# Access Compliance Report

## Public Rights-of-Way

### (Curb Ramps)

Intersection ID: 44317	Main Street: E_9TH_ST	Cross Street: N_CALDWELL_ST	Location: N
ADA ID: 8244B3A67C7F	Ramp Type: PerpDiag	Initial Pass/Fail: Fail	Overall Compliance: No
		Severity Score: 47.5	
Codes/Mitigation Info/Possible Solution		Field Measurements/Component Compliance

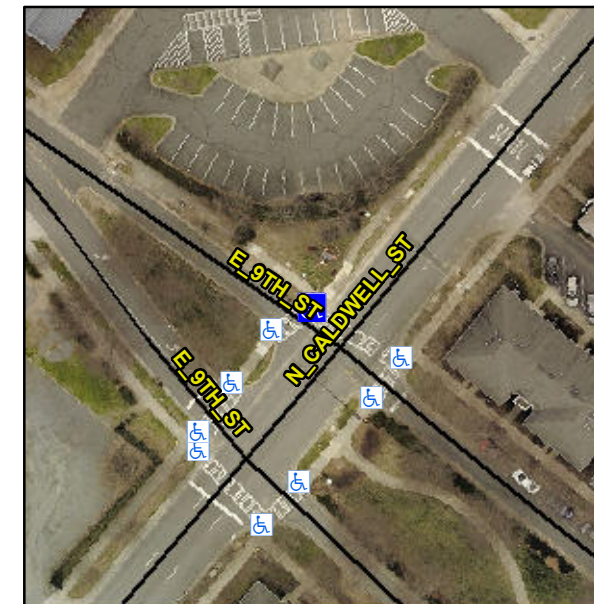
**Not Found, R304.5.1, R304.2.2**

Compliance	Description	Data	Compliance	Description	Data
N/A	Ramp Length (in)	90.0	No	Ramp Slope (%)	11.6
No	Ramp Width (in)	24.0	Yes	Ramp XSlope (%)	1.2
N/A	Flare Type LT	N/A	N/A	Flare Type RT	N/A
N/A	Flare Slope LT (%)	N/A	N/A	Flare Slope RT (%)	N/A
N/A	Flare Traversable LT?	N/A	N/A	Flare Traversable RT?	N/A
N/A	Landing Length (in)	N/A	N/A	DWS Provided?	N/A
N/A	Landing Width (in)	N/A	N/A	DWS Contrast?	N/A
N/A	Landing Slope (%)	N/A	N/A	DWS Length (in)	N/A
N/A	Landing X Slope (%)	N/A	N/A	DWS Full Width?	N/A
N/A	Landing Curb? (Y/N)	N/A	N/A	DWS Offset (in)	N/A
N/A	Shared Landing?	N/A			
N/A	Gutter Ponding?	N/A	N/A	Gutter Slope (%)	N/A
N/A	Gutter Lip Ht (in)	0.5	N/A	Gutter X Slope (%)	N/A
N/A	Painted X Walk1?	Yes	N/A	Painted X Walk2?	Yes
	X Walk 1 Direction	To SW		X Walk 2 Direction	To SE
N/A	X Walk 1 Width (in)	105.5	N/A	X Walk 2 Width (in)	100.0
	X Walk 1 Slope (%)	0.2		X Walk 2 Slope (%)	0.9
	X Walk 1 X Slope (%)	1.1		X Walk 2 X Slope (%)	2.0

**Remove & Replace Curb Ramp With Two New Directional Ramps or Equivalent.**
